**LAND AT HATFIELD AERODROME, OFF HATFIELD
ROAD, HATFIELD, HERTFORDSHIRE**

**PLANNING INSPECTORATE REF: APP/M1900/W/24/3346607
LOCAL PLANNING AUTHORITY REF: PL/0232/21**

**Paper submitted by former Rule 6 parties now third parties
at the request of the Planning Inspector**

Highways and Traffic

Map show weight limits signs within St Albans and Hatfield area

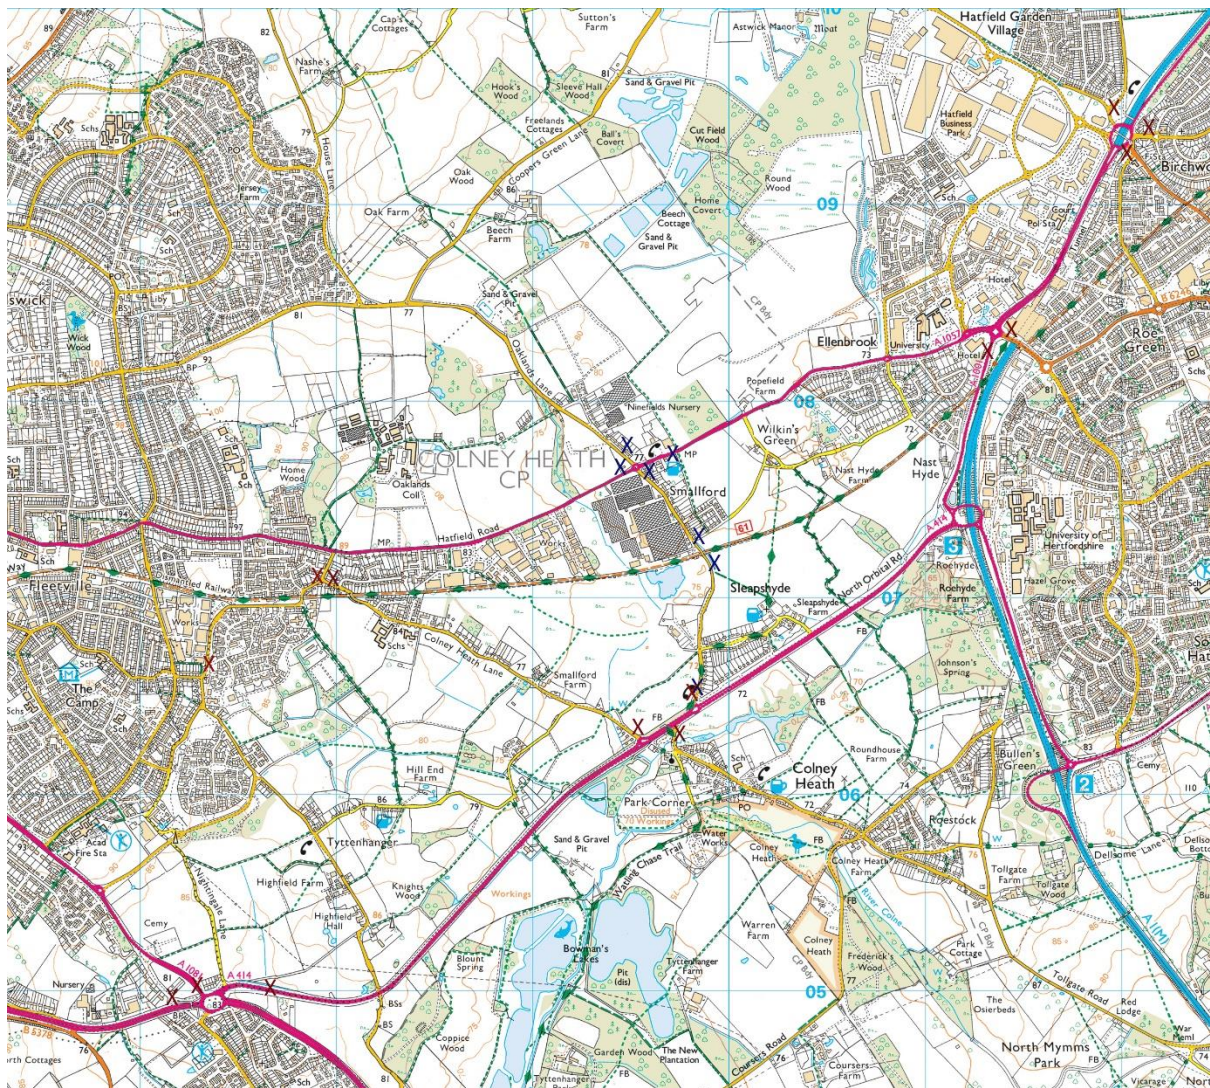
The proposed site is within the St Albans 7.5-ton weight limit and currently no additional signs restrict HGV movement within the area southeast of St Albans other than the weight limits in Station Road, Smallford Lane, Colney Heath Lane and Hill End Lane. The restriction in Station Road and Colney Heath Lane are due to weight limits on old former railway bridges. (See map below).

From a resident's perspective the area has poor or non-existent enforcement of HGV weight limits with lorries regularly travelling through restricted zones.

Map showing the location of the possible highway mitigation (WHBC local Plan)

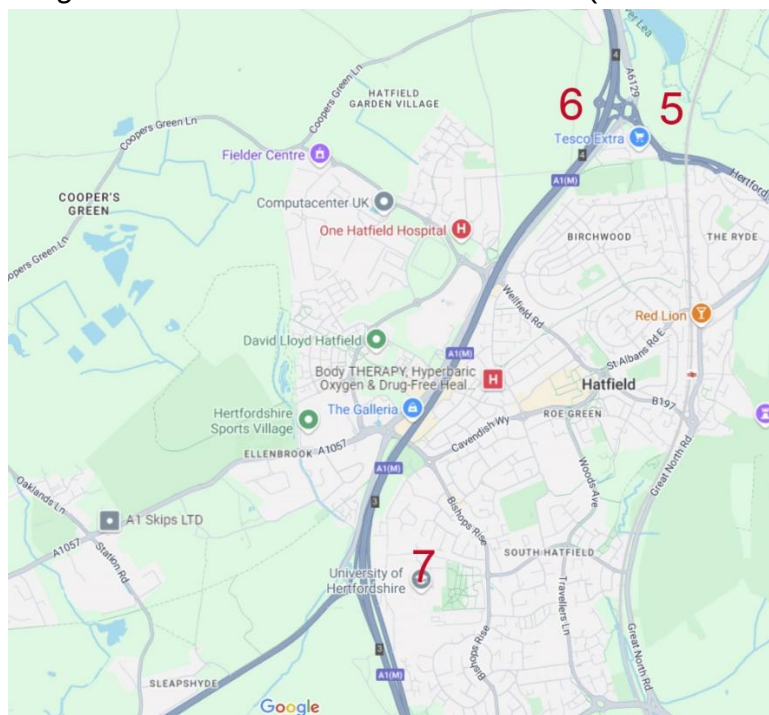
Mitigations schemes have been considered in the WHaSH review and we look at the two most relevant below

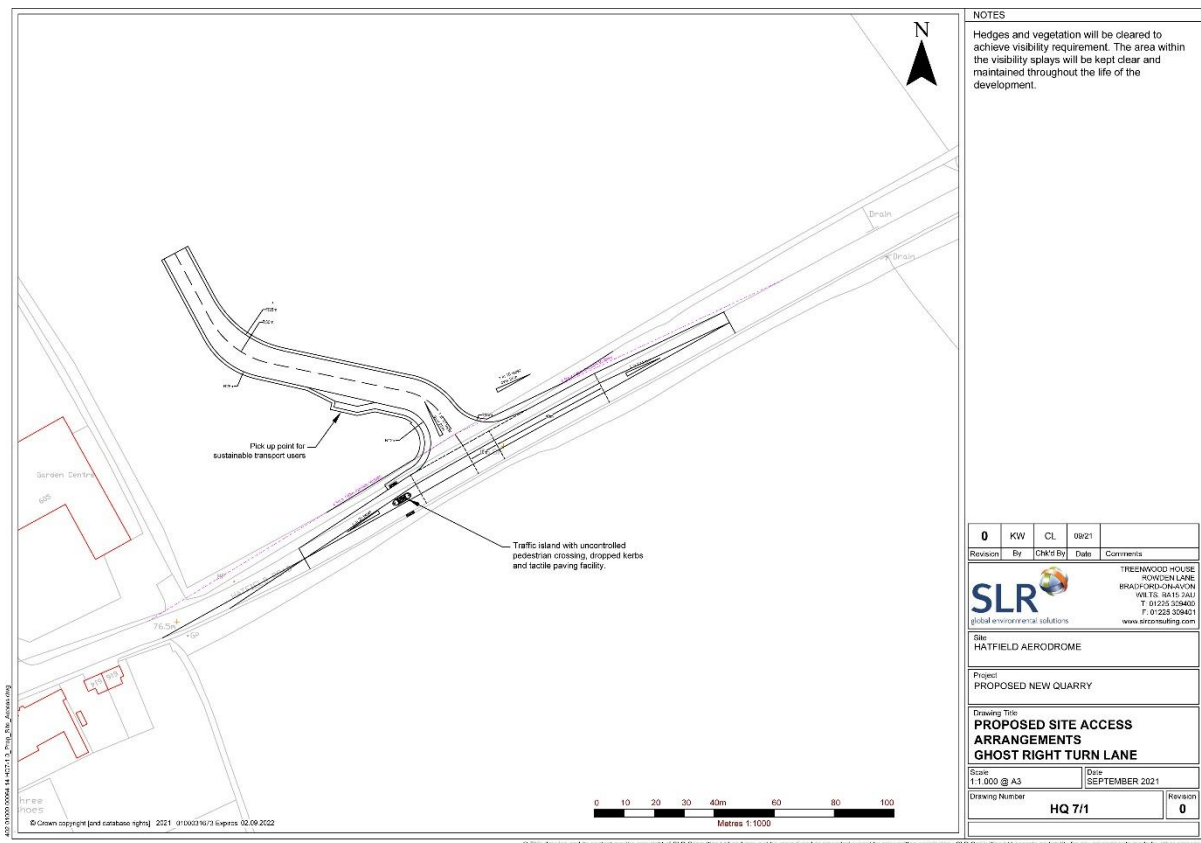
Due to the volumes of traffic using the A414-A1(M) junction 3 roundabout the arm from Comet Way (A1001) has a significantly reduced time for vehicles to join the roundabout. This is a particular issue for fully loaded HGVs due to its moderate incline onto the roundabout resulting often in only one lorry being able to join roundabout at each turn of the lights.
